PCN – Process Change Notification

| Change: | MA208.A.AB.007 |

| Model# | Part Number | Changes |
|---|----------------|---|
| MA.208 Antenna Assembly GPS 3M RG-174 FAKRA Code C 2G/3G/4G 3M CFD-200 FAKRA Code D | MA208.A.AB.007 | Product part number, labels, heat-shrink tubes and 3M double-sided adhesive foam. |

Illustration of Change (MA208.A.AB.007)
Old Drawing

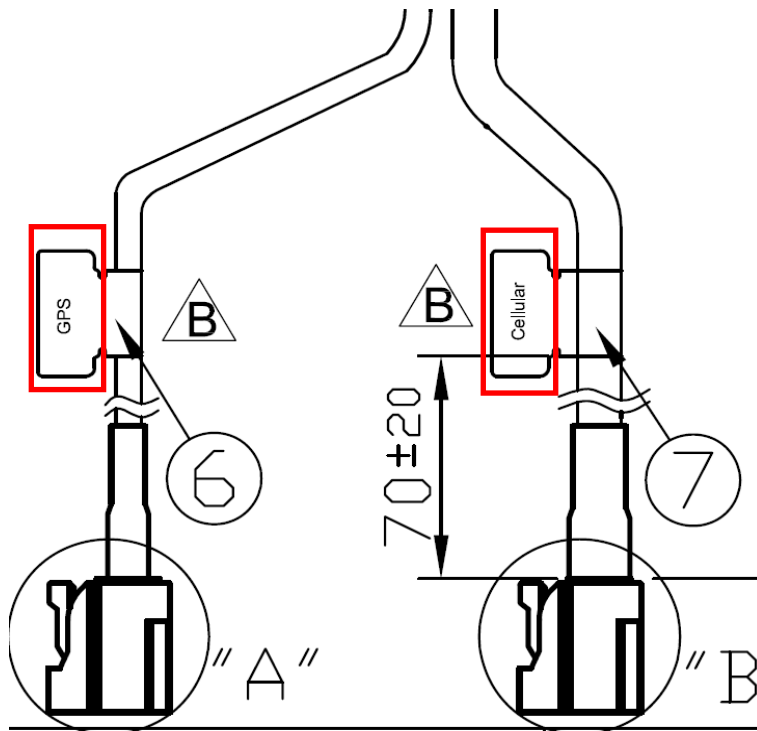
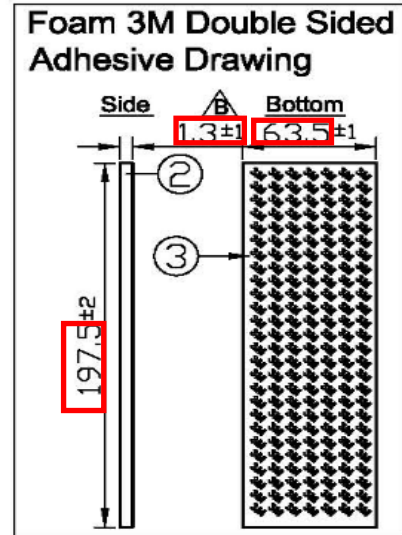
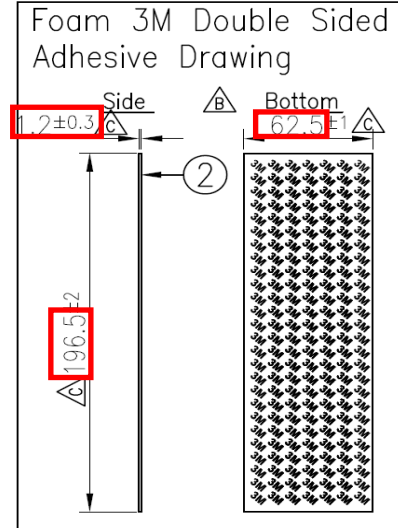
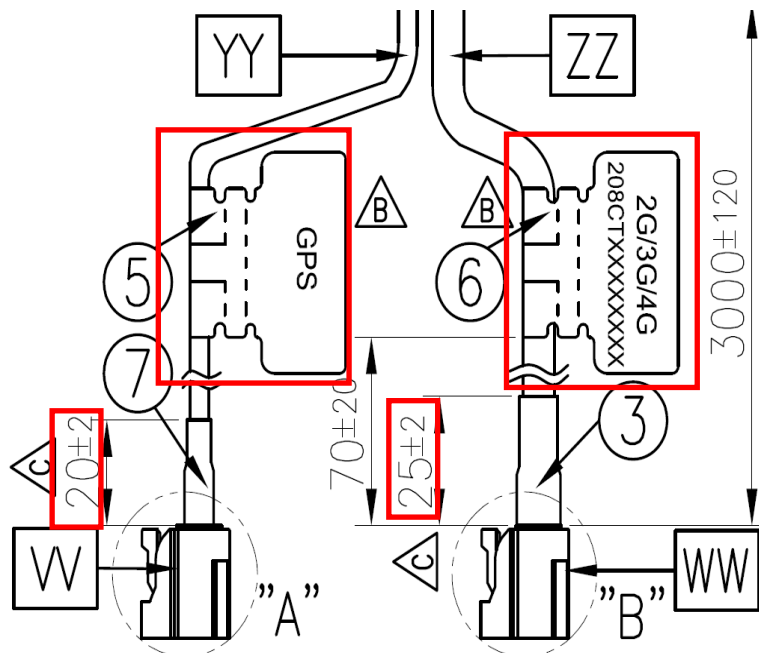
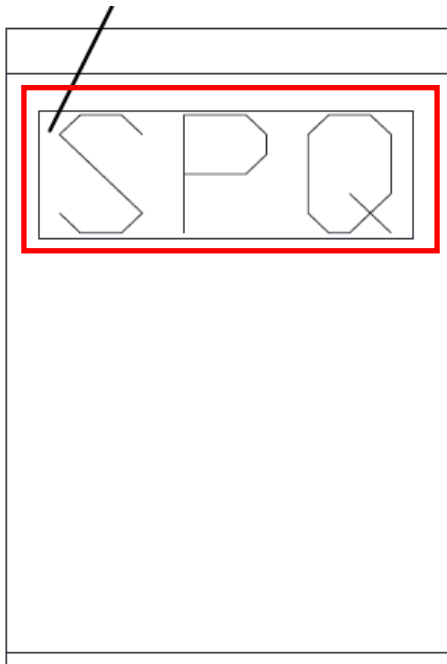
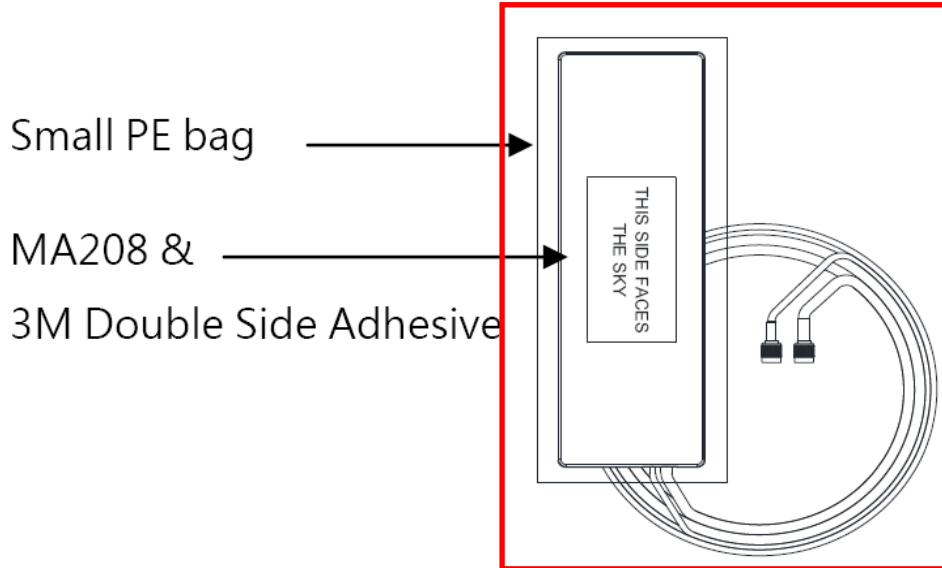
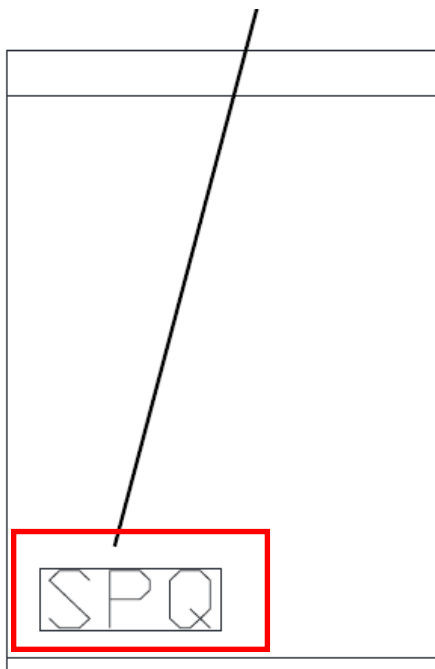
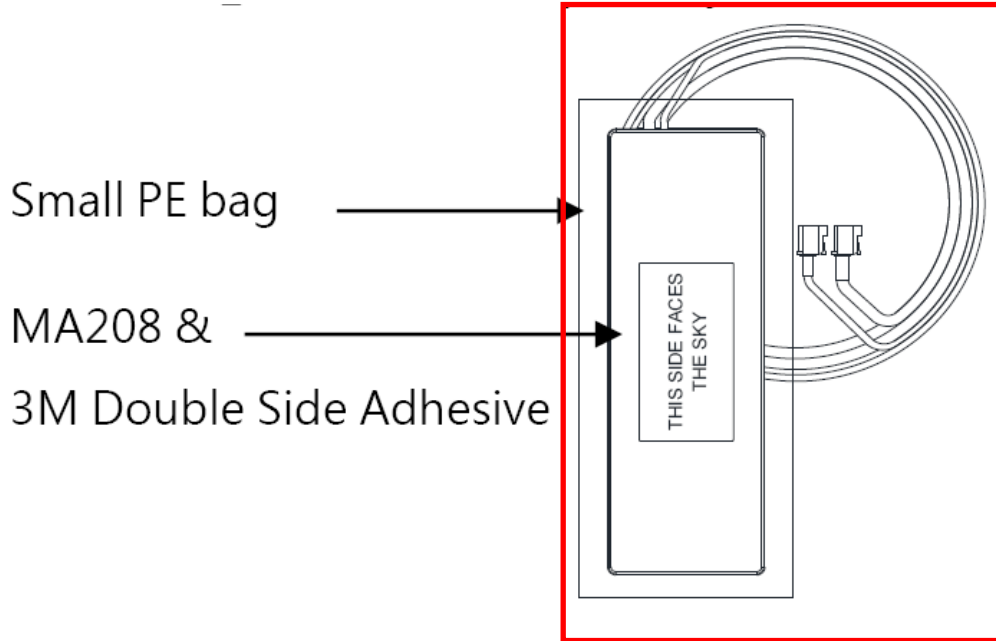
1. Amend the part number from MA.208.A.AB.007 to MA208.A.AB.007
2. Amend Cellular Label to white 2G/3G/4G Label and the direction.
3. Add Heat-Shrink tube dimensions and tolerances.
4. Amend 3M double-sided adhesive foam dimensions and tolerances
5. Amend product bagging direction and change product SPQ label to bottom left position on the large PE bag.
